**Subject: Response to First Request for Additional Information  
Permit Application to Construct Phases I and II  
Vista Landfill, Class III (Facility ID 87081)  
Apopka, Florida  
(Permit No. SC48-0165969-014)**

Subject: Response to First Request for Additional Information  
Vista Landfill, Class III (WACS #87081)  
Permit Application No. SC48-0165969-019  
Orange County, Florida

Orange County – SW WACS # 87081  
Vista Landfill, Class III  
First Request for Additional Information  
Permit Application No. SC48-0165969-019

DESIGN BY: VMD & JWO DATE: AUGUST 2012  
DRAWN BY: JWO & CMV PROJECT NO.: FL2066  
CHECKED BY: VMD FILE: FL2066.01P060B  
REVIEWED BY: KBT DRAWING NO.:  
APPROVED BY: VMD **6B** OF **23**

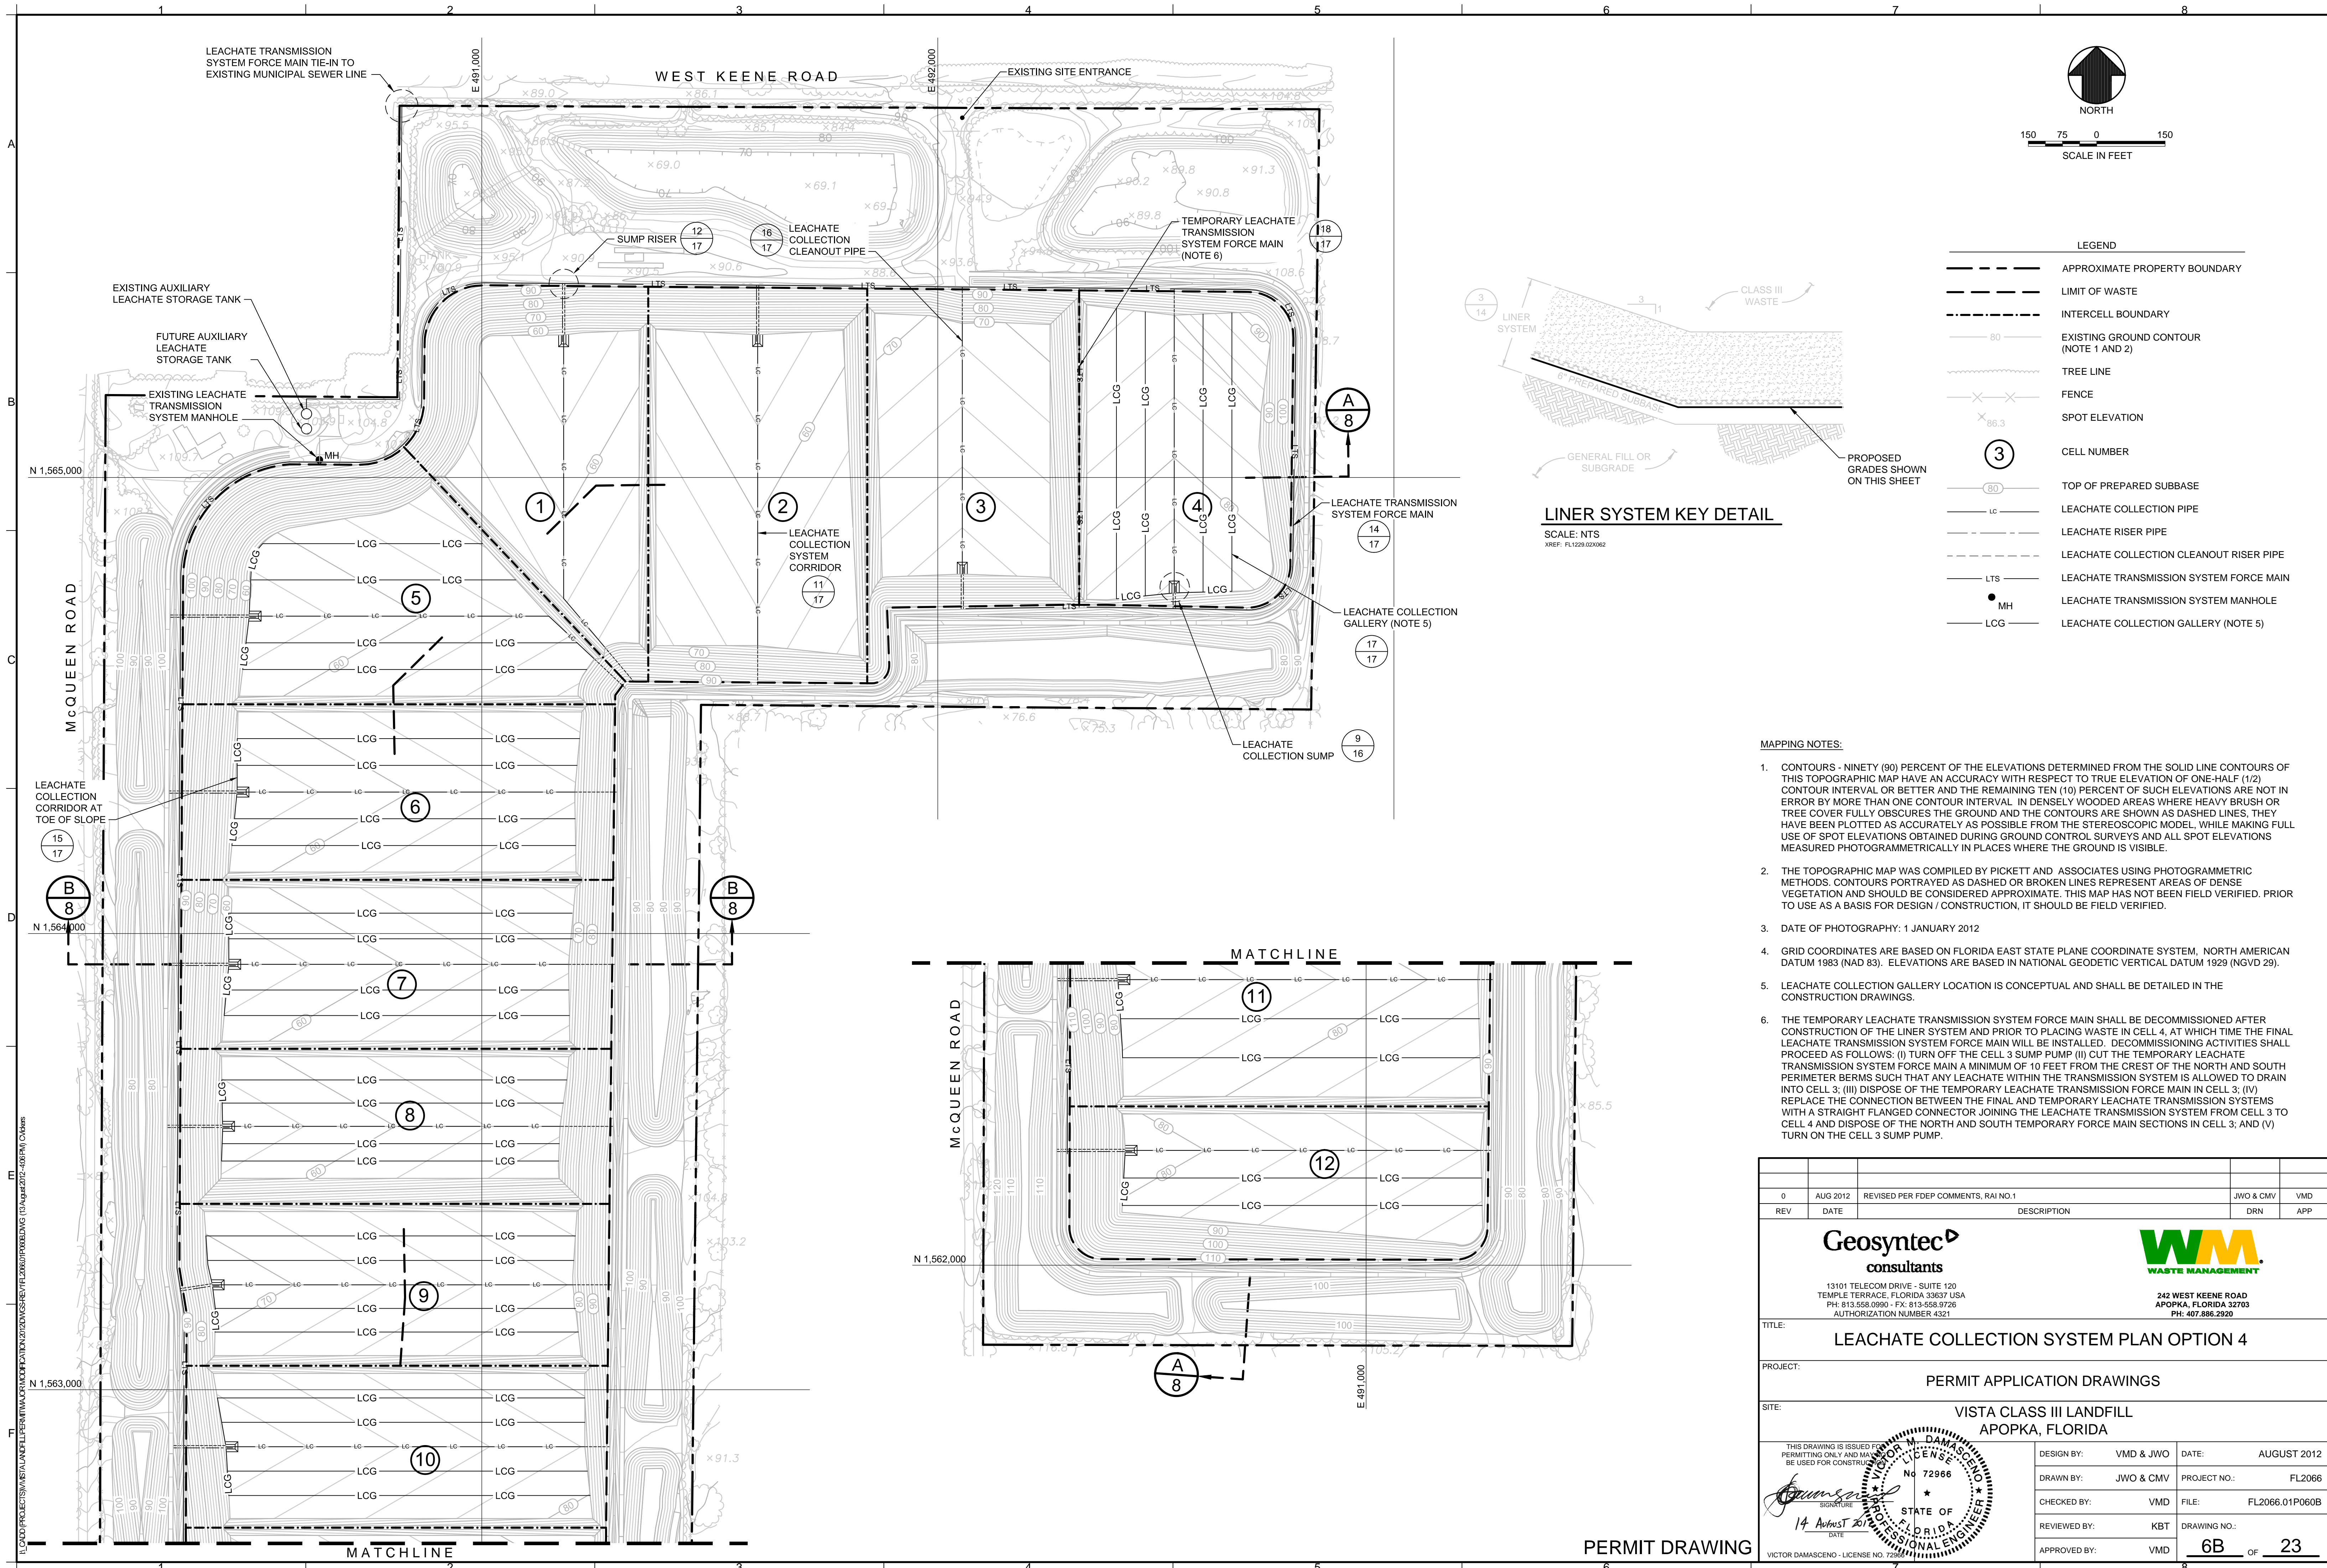
*Is the Department's understanding of the construction permit application correct? If yes, provide a separate drawing for each of the above options (the drawings should be similar to*

*Drawing 6 in the report). The drawings should refer to the corresponding details on drawings 14 and 17. If no, please describe each design and make sure there is a separate drawing for each one.*

FDEP's understanding of the construction permit application is correct; there are four potential layouts for the leachate collection system at the Vista LF facility, two of which are conceptual (i.e., Options 3 and 4). The permit drawings submitted with the 12 July 2012 Permit Application have been revised and replacement sheets are provided as Attachment B of this letter as agreed upon during the meeting. Two additional sheets (6A and 6B) have been prepared and are included with the revised replacement sheets in Attachment B.

As discussed during the meeting, the leachate collection gallery design varies with each cell based on the drainage length and properties of the sand. Therefore, the cross sections provided in the revised permit drawings have been updated to provide a conceptual design for the galleries (i.e., no dimensions for the width of the leachate collection galleries are provided). A minor permit modification will be submitted to FDEP for approval prior to cell construction should WMIF choose to pursue Options 3 or 4. Note that, as stated during the meeting Cell 3 will be constructed using Option 1.

**C** SECTION  
**14** INTERCELL BERM OVER FLOW  
 SCALE: 1" = 4"  
 XREF: FL2066.01X0043

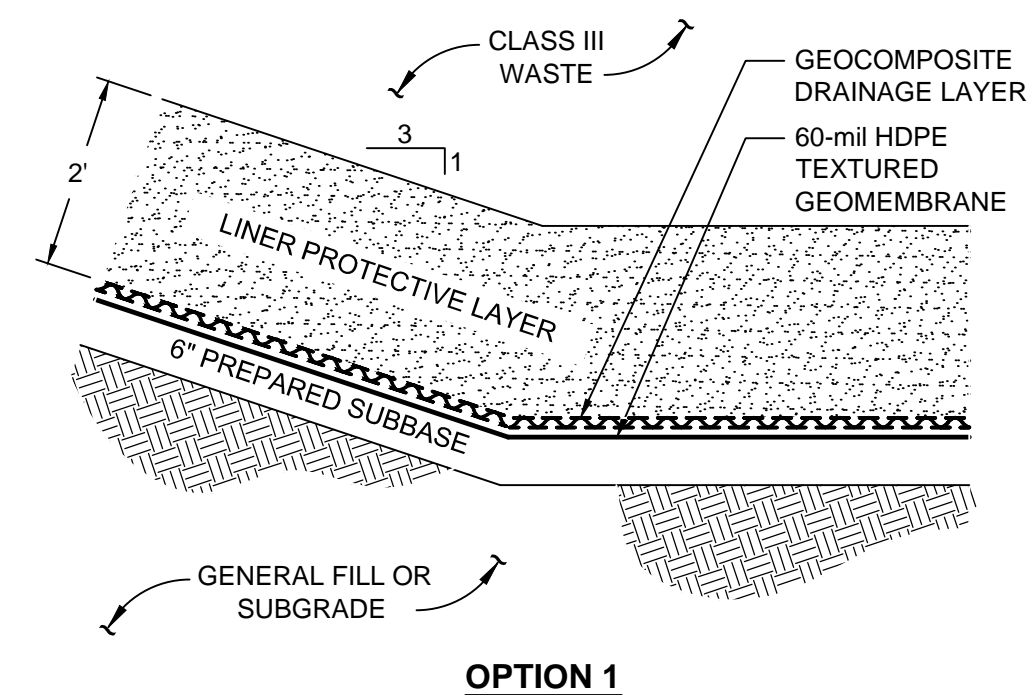
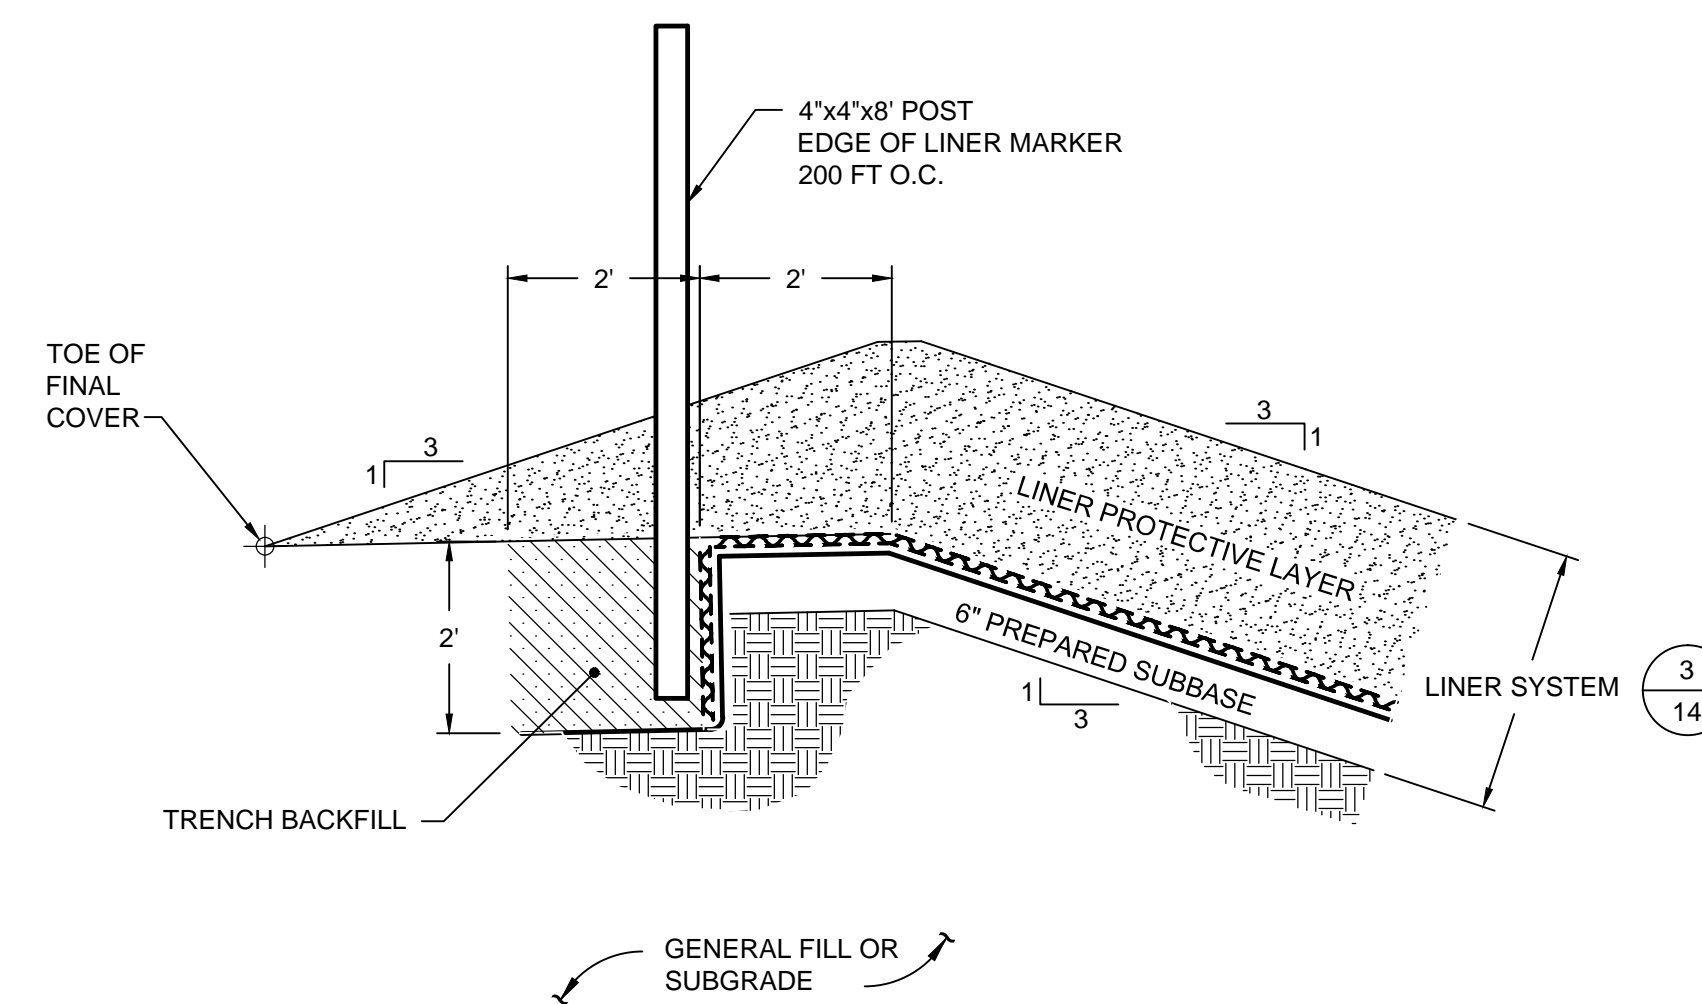
10. *Drawing 14, Liner System Details, depicts the anchor trench detail for the perimeter berm (detail 5) and the anchor trench detail for the intercell berm over flow (detail C). The following are comments and questions regarding the anchor trench design.*

- a. *Detail C depicts the geocomposite extending to the edge of the berm. Exposed geocomposite, as depicted on detail C, may be a violation of the site’s Title V Air permit since it has the potential to be a landfill gas emission pathway. Please consult with the applicable Air Program to determine compliance with all air regulations. The Solid Waste Program recommends wrapping the end of the geocomposite drainage layer with the underlying geomembrane to eliminate a potential pathway for landfill gas and odors.*

- b. *Detail C depicts the geocomposite extending to the edge of the berm and references detail 5; detail 5 depicts the geocomposite extending down into the anchor trench with the geocomposite. Which design is correct?*

Detail 5 “Anchor Trench at Crest of Perimeter Berm” of Sheet 14 is the correct design. Section C “Intercell Berm Over Flow” on Sheet 14 has been revised and updated accordingly. The respective replacement sheet is provided in Attachment B.
